This addendum contains new and changed information for the SYM53C810A Data Manual Version 2.0, published in August 1996. The information will be added to the next version of the manual. The changes are listed in the order in which their appropriate chapters appear in the data manual. The Power Management features of the SYM53C810AE enable it to comply with Microsoft's PC 97 Hardware Design Guide. This addendum applies to both devices, SYM53C810A and SYM53C810AE, except where noted.

Chapter 2, Functional Description

Figure 2-4: Determining the Synchronous Transfer Rate

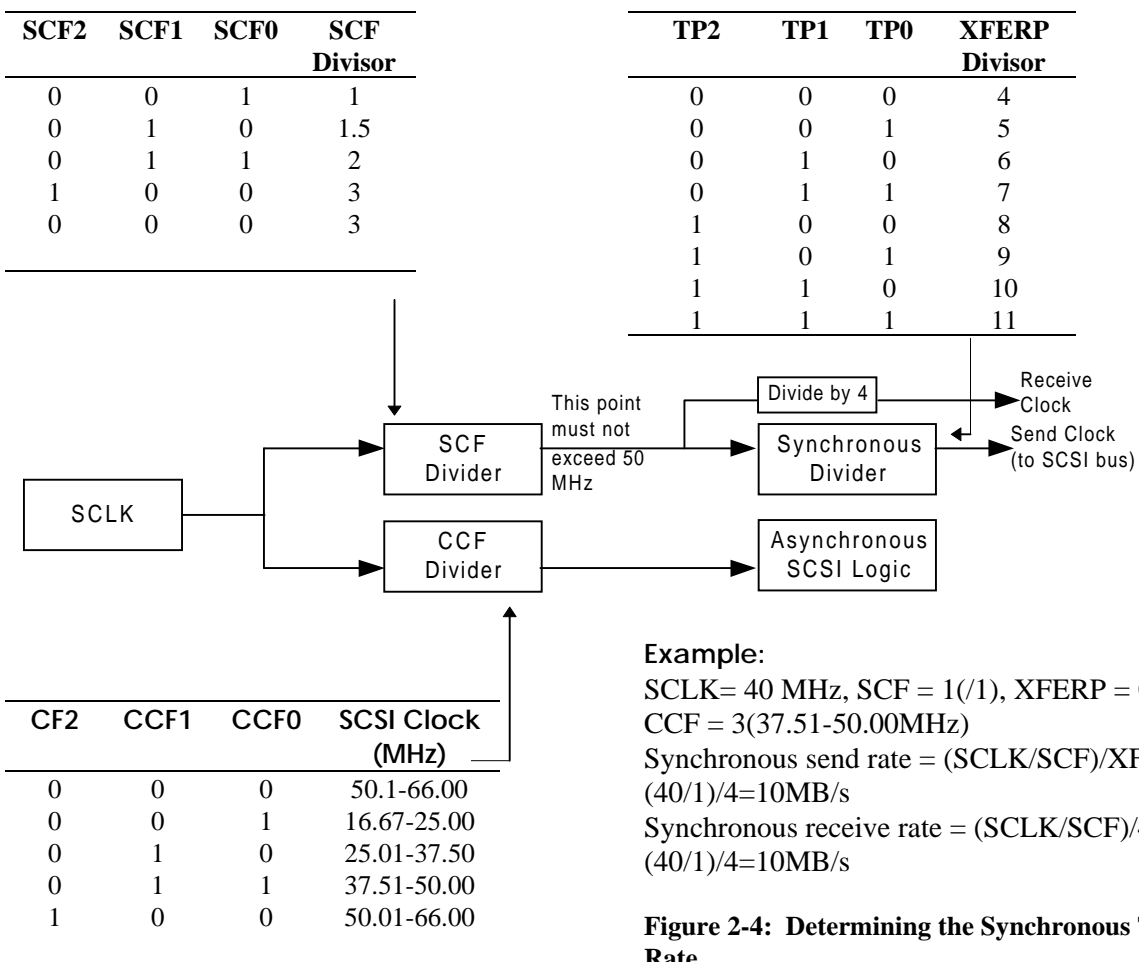
Figure 2-4, "Determining the Synchronous Transfer Rate," was inadvertently omitted. See the reference to this figure under the main heading "Synchronous Operation." The drawing appears below.
